# “Discounting Reality” on Church Hill Woods

Adapted from Party-in-Interest  
Comment at Durham Planning Board

**February 23, 2022**

Joshua Meyrowitz, 7 Chesley Drive,  
Durham, NH

**Toomerfs' parking mound project site, as seen from Andersens' Dining Room at 8 Chesley Dr**

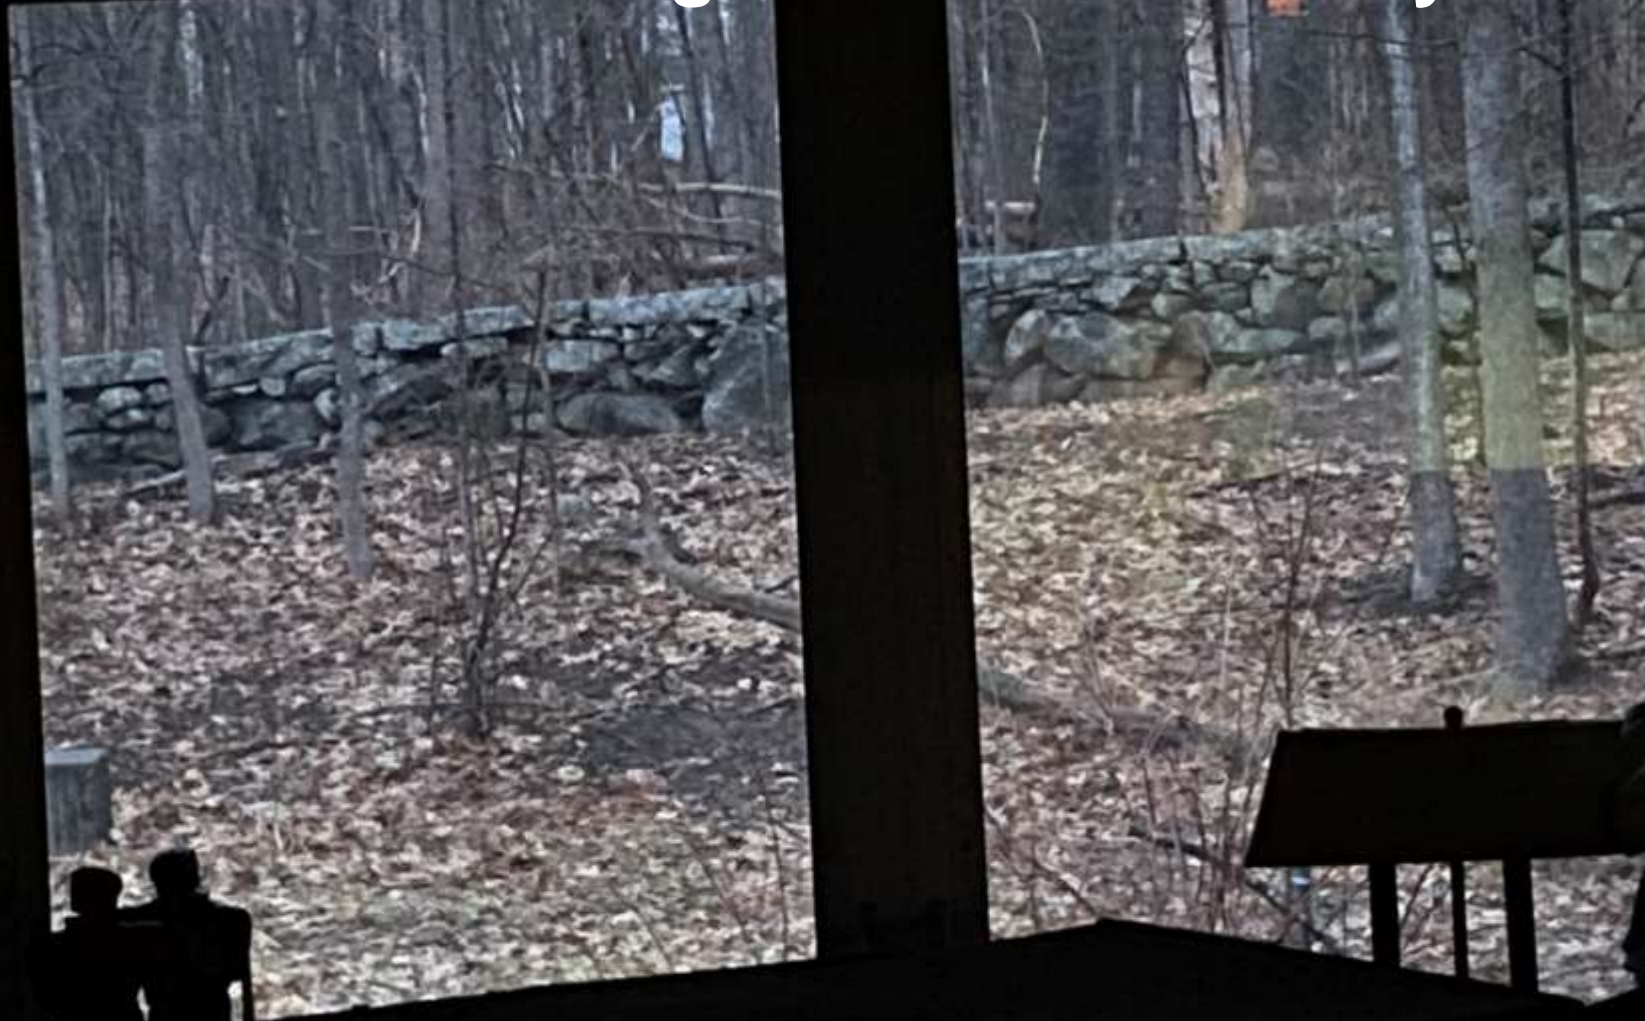
**Contrary to Toomerfs' claims: project NOT at "rear" for the most affected homes**

**Despite multiple requests from residents & Planner Behrendt, Toomerfs have NOT provided parking-structure renderings from abutting 5 Smith Park Ln Urso home**

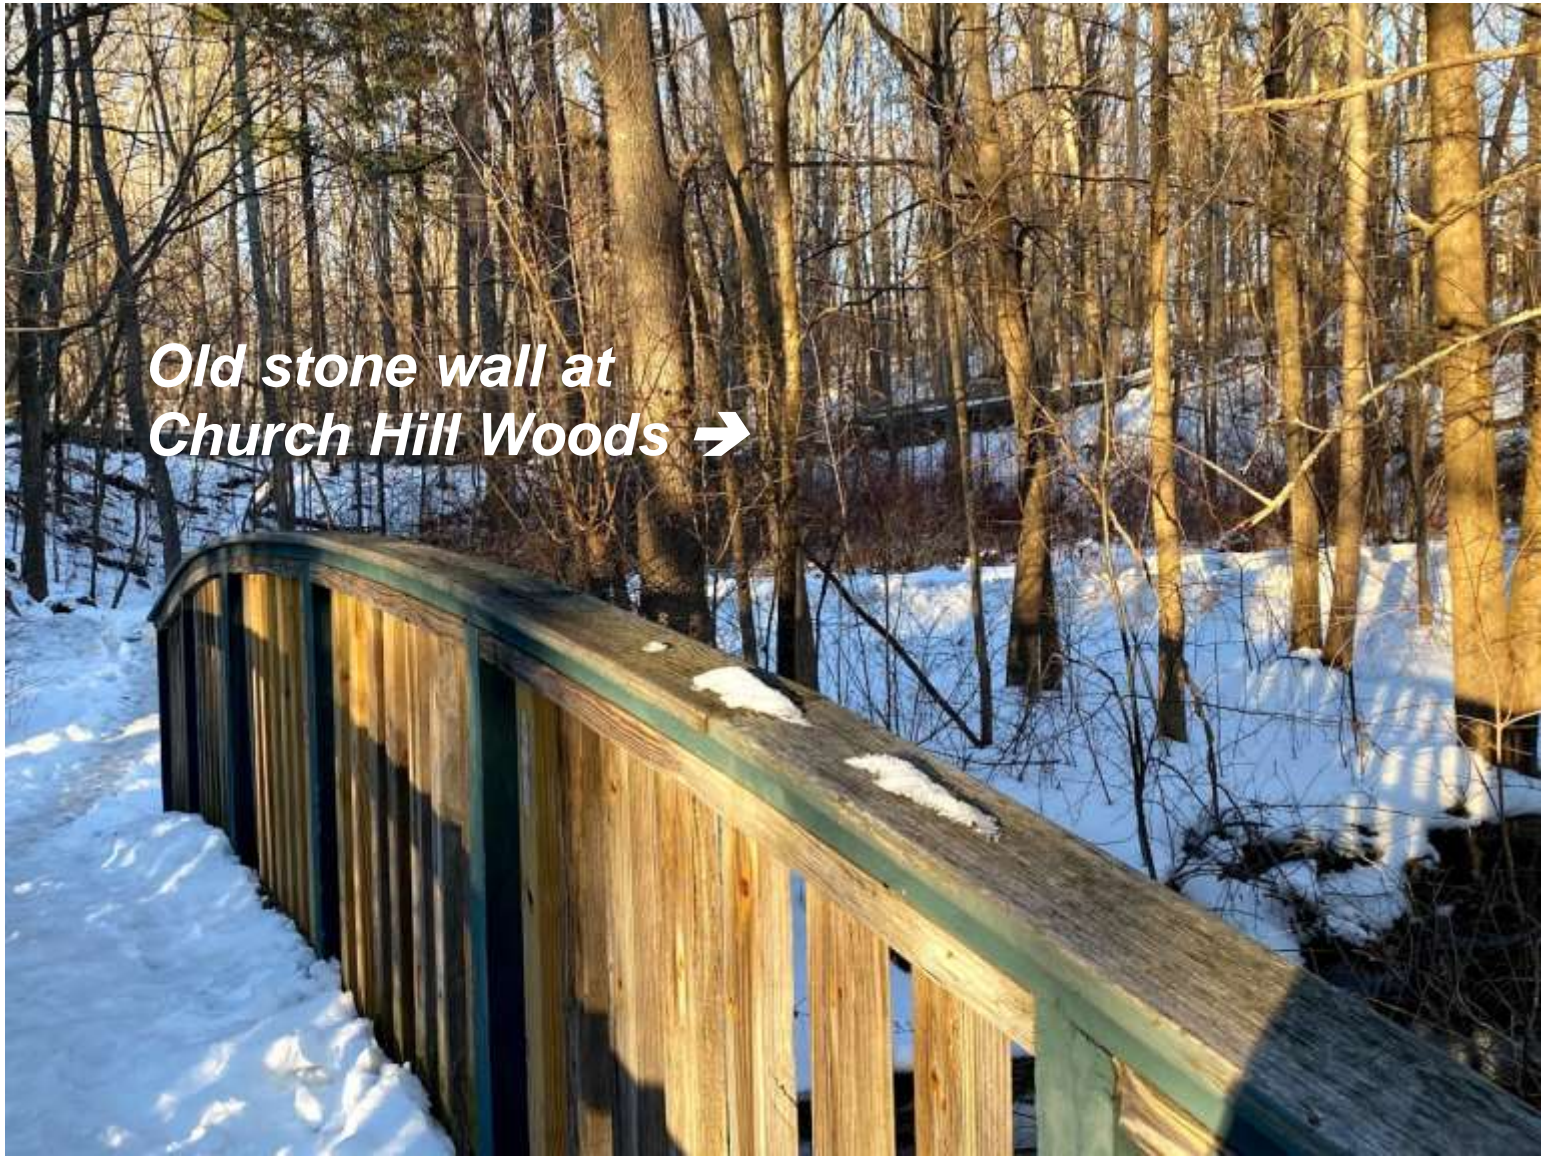
**Retaining-slope crest line would be *aimed directly at the Urso house*, with large mound of fill/asphalt & 24-hr lighting replacing steeply sloped woods.**

*Mike Sievert: “scale is respectful of what is out there because it’s **set back onto our property....**”*

What engineer Mike Sievert refers to as the “back” of the property is **FRONT** of property to **Red Tower Development & Faculty Neighborhood**, Durham’s largest family neighborhood (about 300 households).

**Toomerfs' parking mound project site, as seen from  
2<sup>nd</sup> floor\* master bedroom at 7 Chesley Dr**

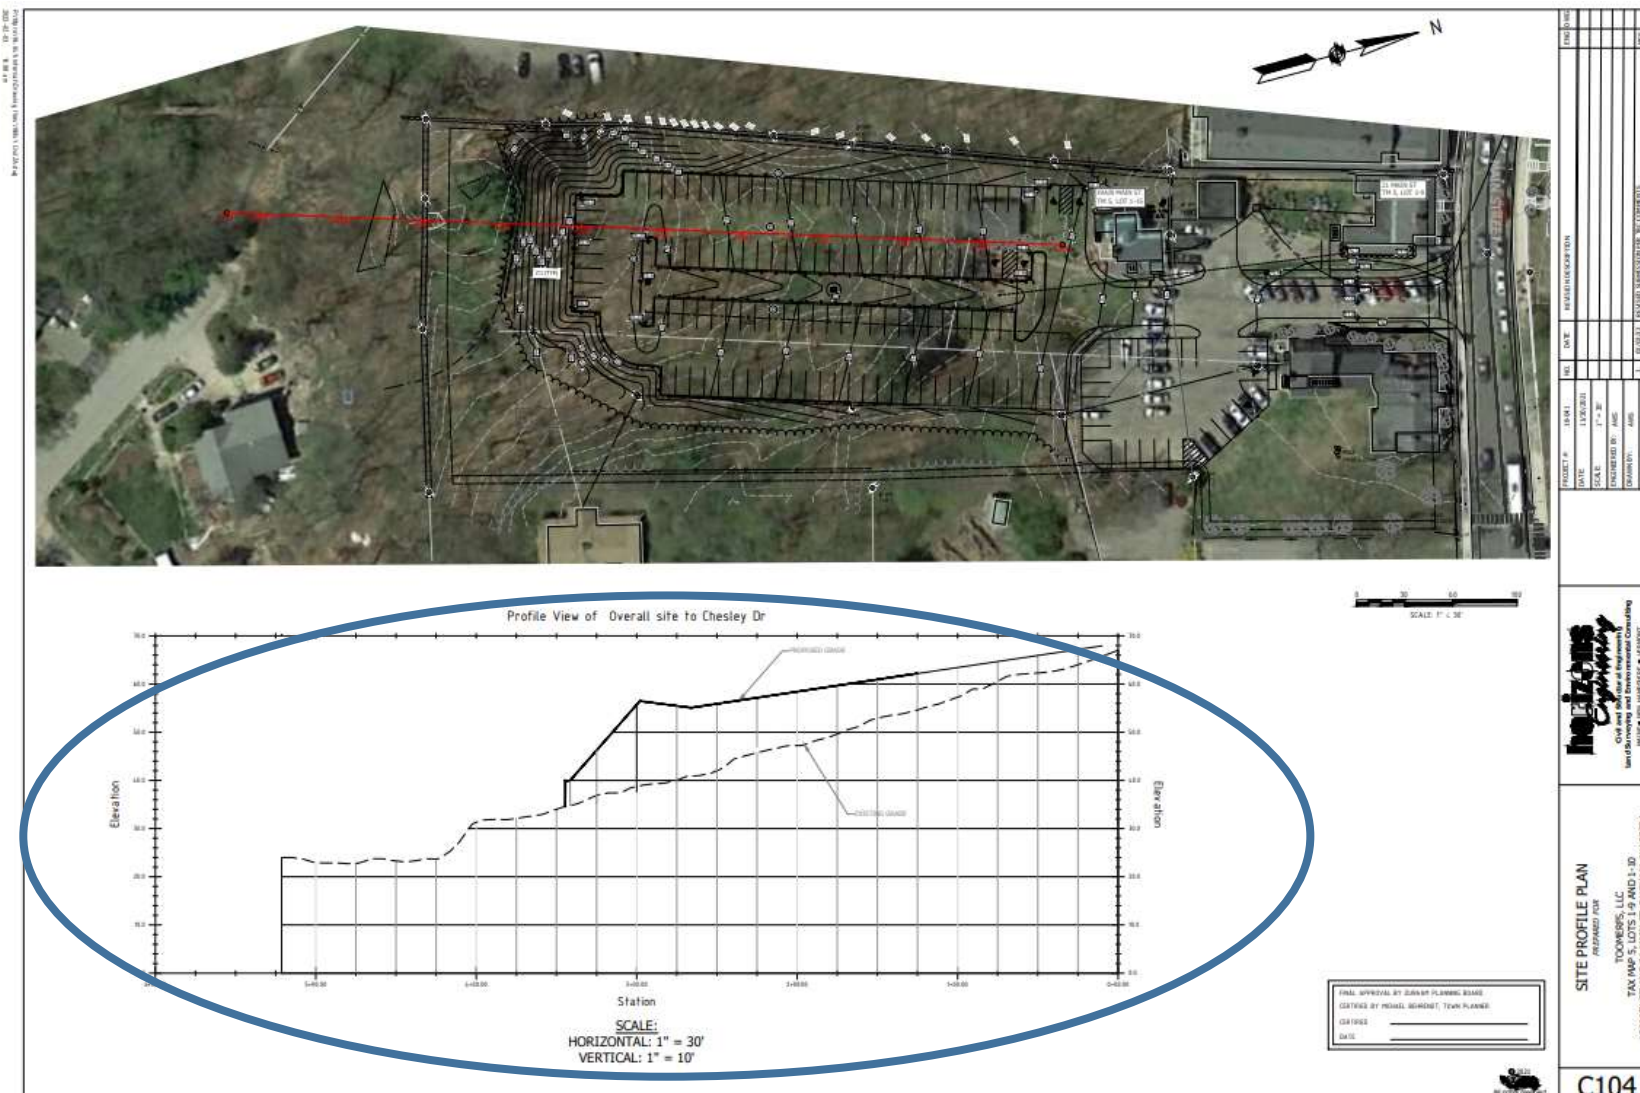
**Contrary to Toomerfs  
claims: project NOT at  
"rear" for the most  
affected homes**

**\*Starting over 2 stories up, the Toomerfs towering 18.5-ft mound & 14-ft lighting  
would reach 5+ stories height above Chesley Dr street level.**

*Portrayal of the existing grade & proposed denuded/elevated grade) down to Chesley Dr.*

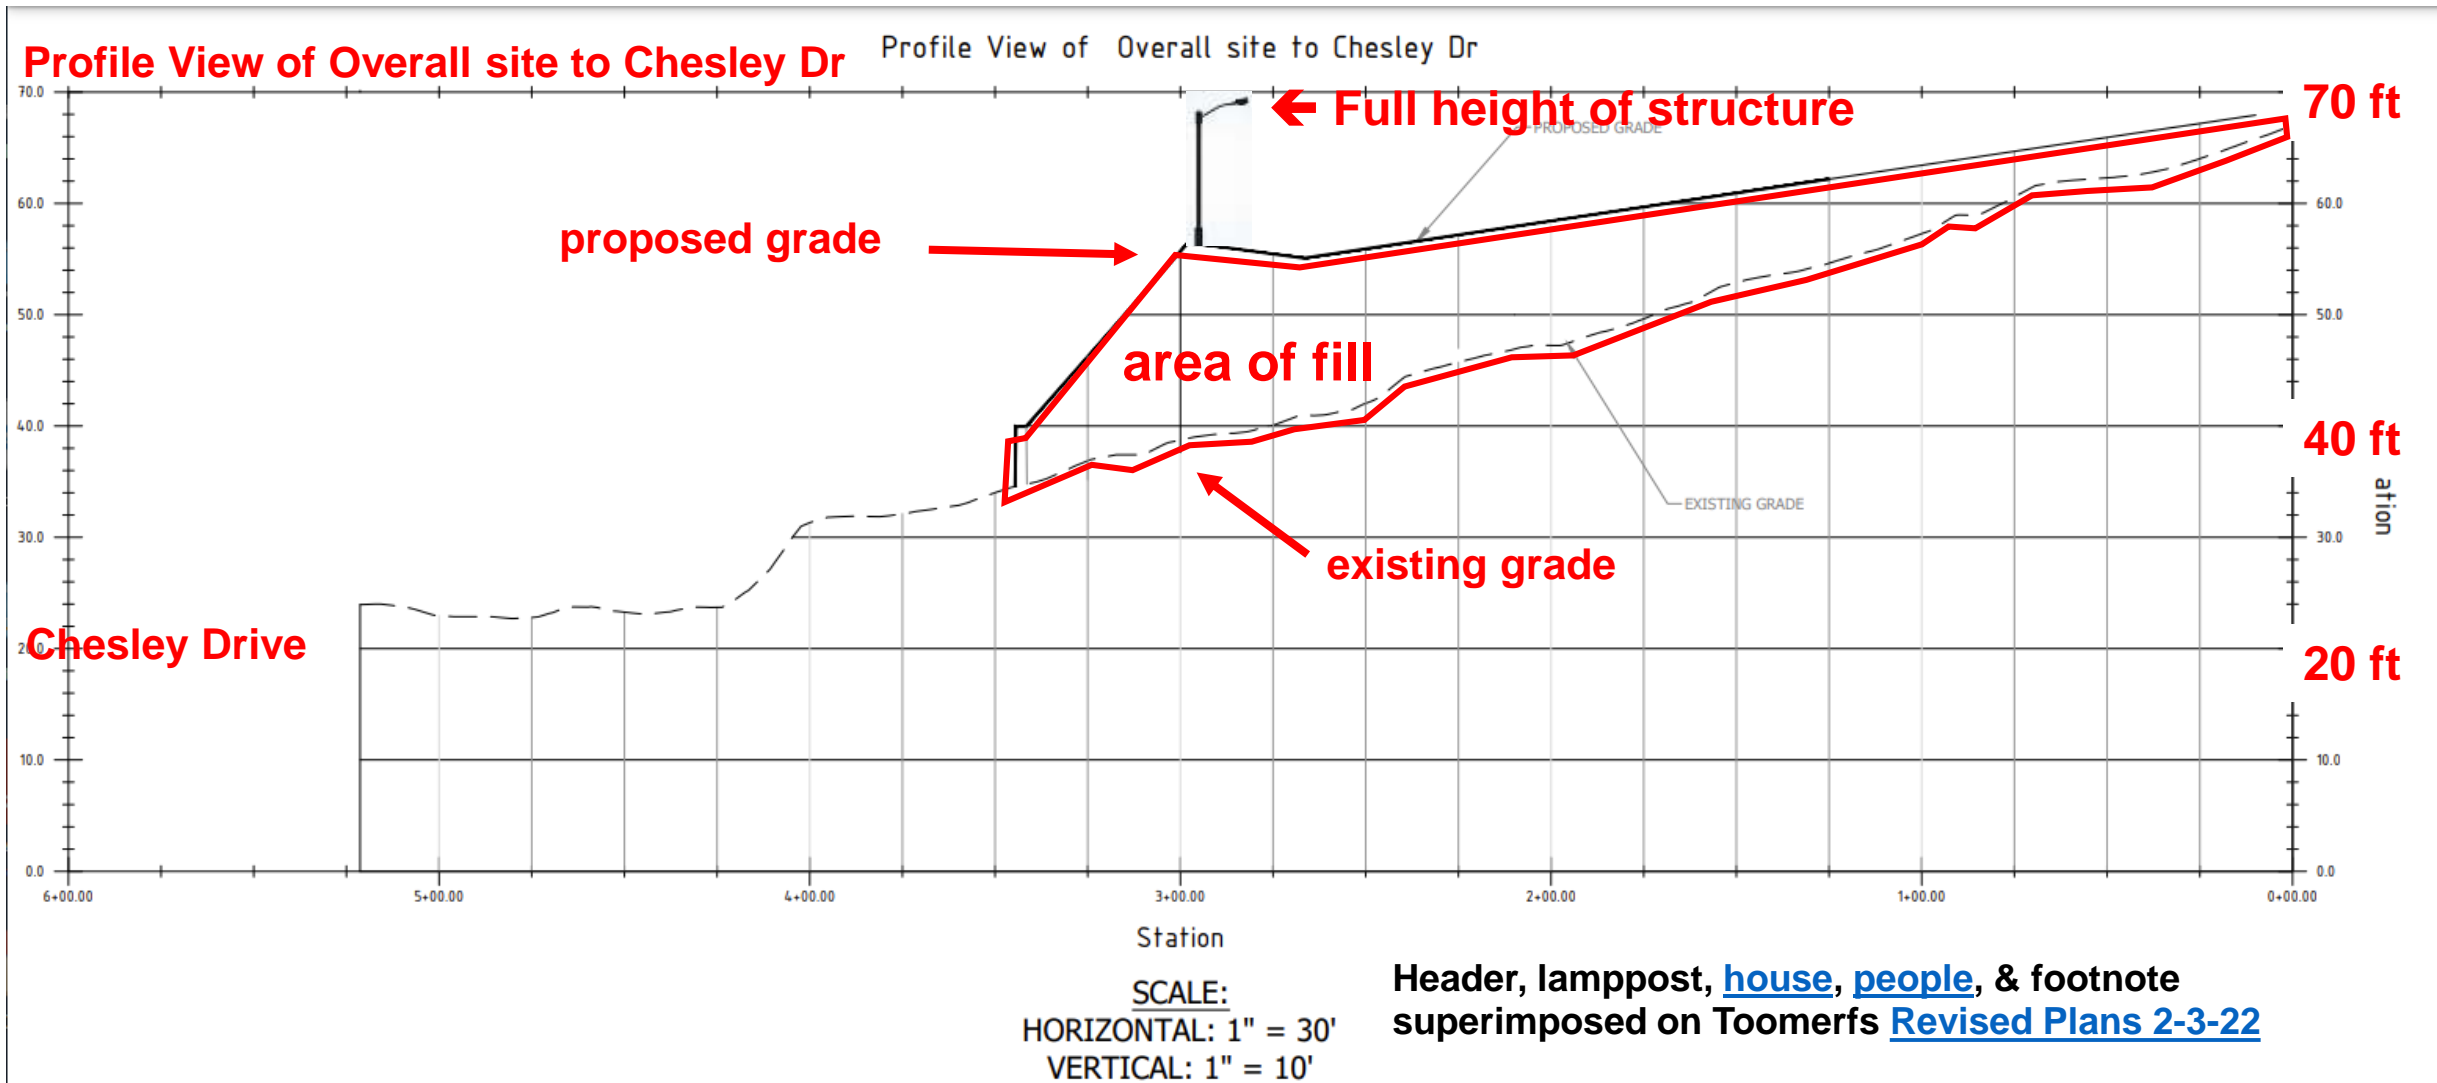
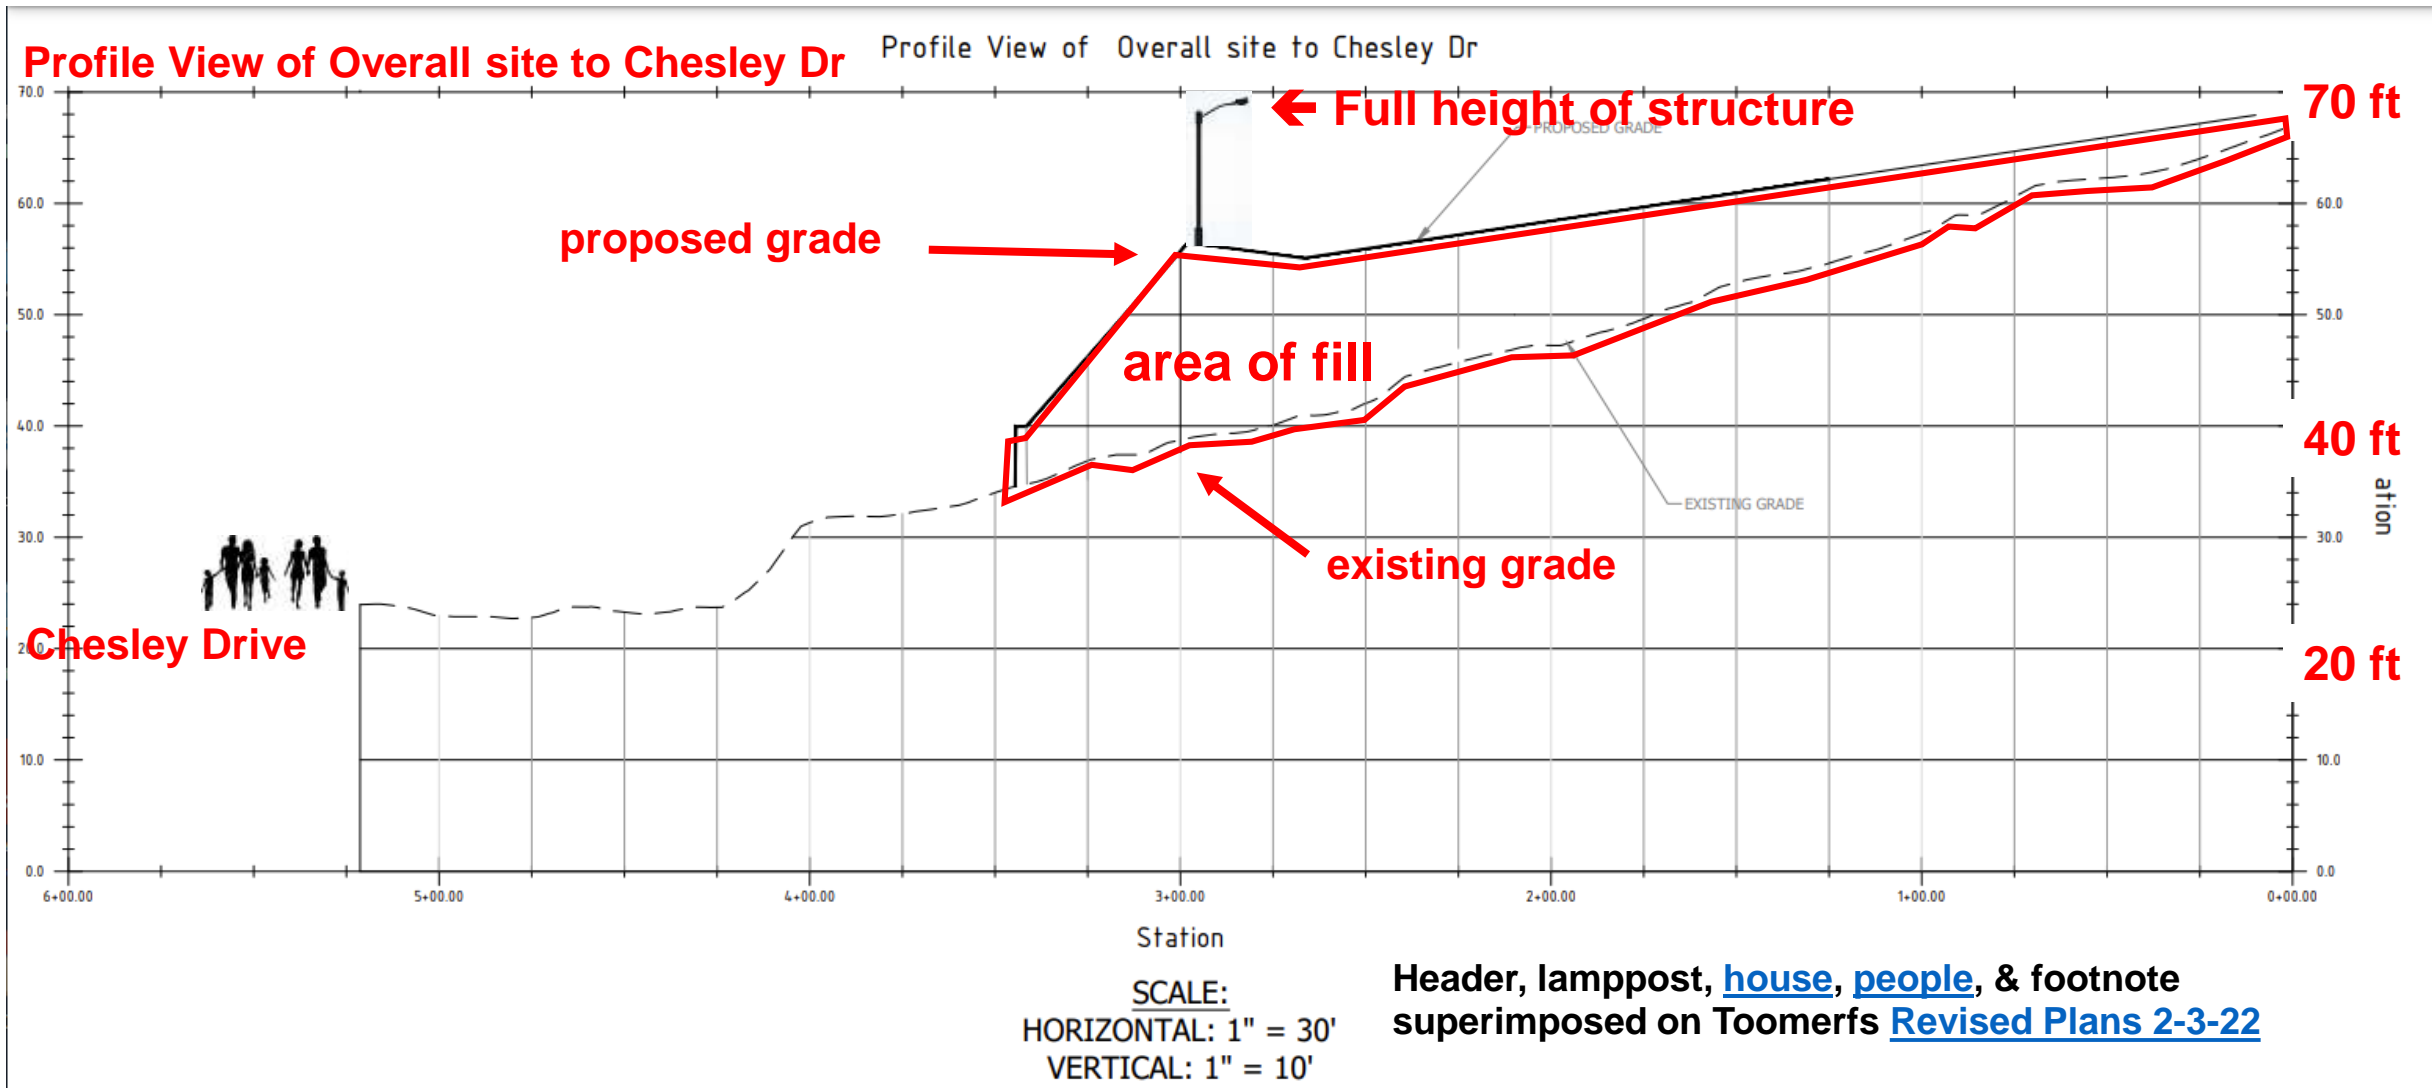
**Finally: Arrival of long-delayed site profile:**  
After 28 months of requests for it, Toomerfs finally submitted a profile of the Church Hill Woods.

But it's a tiny image, occupying only the bottom half of a page, [Revised Plans 2-3-22](#), page 7, with nearly invisible elevation numbers and almost no explanation.

**After deforesting Church Hill Woods: Up to 18.5 ft of vertical fill + asphalt topping + 14-ft lighting poles will sit atop hillside that is already about 16 ft above Chesley Dr street level ( $16 + 18.5 = 34.5 + 14 = 48.5+$  ft)**
